A-579388

636 & 637 TYPE TELEPHONE SET WIRING DIAGRAM

WESTERN ELECTRIC CO. INC.
ENGINEER OF MANUFACTURE

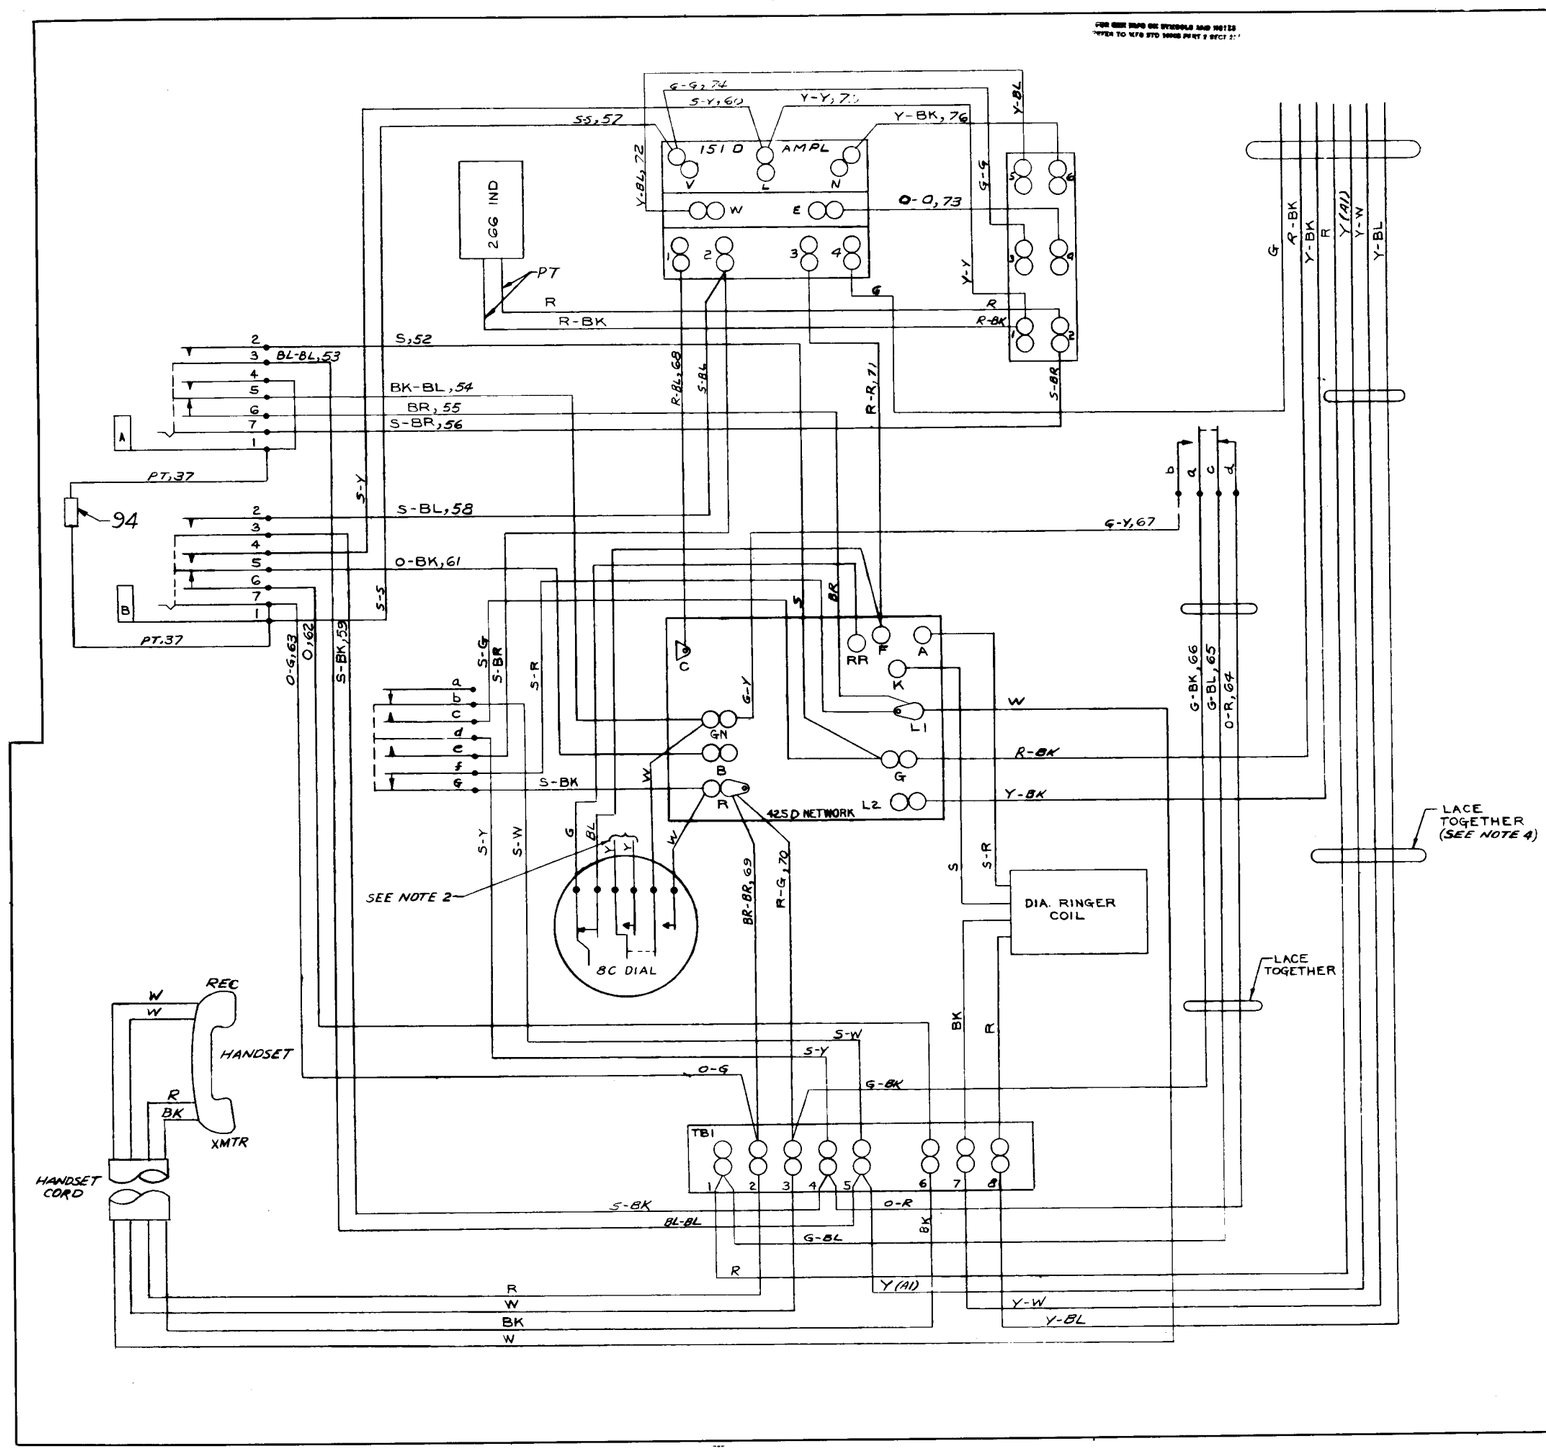
1. ~~ITEM NUMBERS REFERRED TO ARE SHOWN IN STOCKLIST OF ASSEMBLY DRAWING A-570260.~~
2. DEAD DRESS THESE SPADE TIPPED LEADS PER A-050071-39 AND STORE.
3. PT-LEADS FURNISHED WITH COMPONENT.
4. LACE CONDUCTORS INDICATED, FOR 7 INCHES, WITH LACING TAPE, ITEM 77.
5. ~~WHEN A 617A KEY IS INCLUDED IN THE TEL. SET THE RED 8 INCH LONG SPADE TIPPED LEAD FROM THE SG TERMINAL ON THE 617A KEY IS TO BE CONNECTED TO THE SG TERMINAL ON TERMINAL STRIP II OF THE D6D8 CORD (ON THE 10 BUTTON SET OR TERMINAL STRIP III OF THE D200B CORD (ON THE 30 BUTTON SET).~~

ISSUE-1 4-29-40
425 D NETWORK DESIG. WAS 425B NETWORK. (SUPP NO 1 TO 441814-AIC-1)

ISSUE-2 7-29-60
ADDED: NOTE 5
CHANGED: TITLE WAS 636 A1 TYPE TEL. SET WIRING DIAGRAM. (SUP 636 A1 & 637A1 TEL. SETS)

ISSUE-3 8-10-60
ITEM NOS. CHANGED TO AGREE WITH TRANSFER OF STOCKLIST INFO FROM A-579269 TO 579505 & A-579506; NOTES 1 & 5 READ AS IN CROSSHATCHED NOTES 1 & 5. (REISSUE EIR 636A & 637A1 TEL SETS)

ISSUE-4 12-9-60
CHANGED: THE S-52 SG, R-BK & Y-BK LEADS WERE SHOWN CONNECTED TO TERM. L2, TERM. L2, TERM. L2 & TERM. G OF THE NETWORK RESP; THE Y(A1) LEAD SHOWN CONNECTED TO TERM. 5 OF 721 WAS BR(A1); (442120-1)

1. ITEM NUMBERS REFERRED TO ARE SHOWN IN STOCKLIST OF BASE ASSEMBLY AND CORDING DIAGRAM, P-BIN 600-399.
5. WHEN A 617A KEY IS USED IN THE TELEPHONE SET ATTATCH THE SPADE-TIPPED CONDUTOR OF THE KEY TO THE SG TERMINAL ON THE MOUNTING CORD TERMINAL STRIP. REMOVE THE SPADE-TIPPED STRAP FROM THE CG TERMINAL ON THE STRIP
